PCN-20201004 TE0876-02 SPI Flash Change

Company	Trenz Electronic GmbH
PCN Number	PCN-20201004
Title	TE0876-02 SPI Flash Change
Subject	BOM change
Issue Date	2020-10-06

This change affects all Trenz Electronic TE08760 modules of revision 02.

#1 Change SPI Flash from N25Q064A13ESE40F to IS25LP064D-JBLE

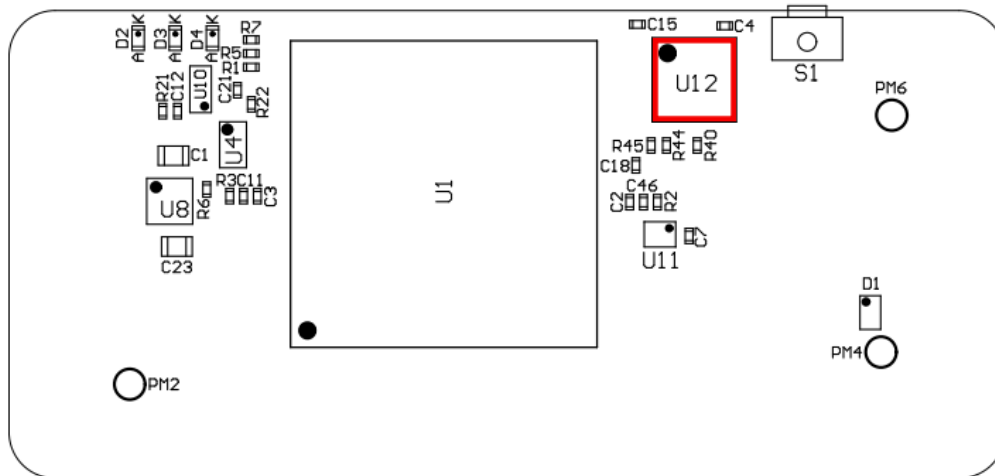
Type: BOM change

Reason: Old flash is obsolete.

Impact: JEDEC ID changes from BA17h to 6017h and manufacturer ID from 20h to 9Dh.

Locate Flash (U12) at top side of PCB:

N25Q064A13ESE40F

IS25LP064D-JBLE
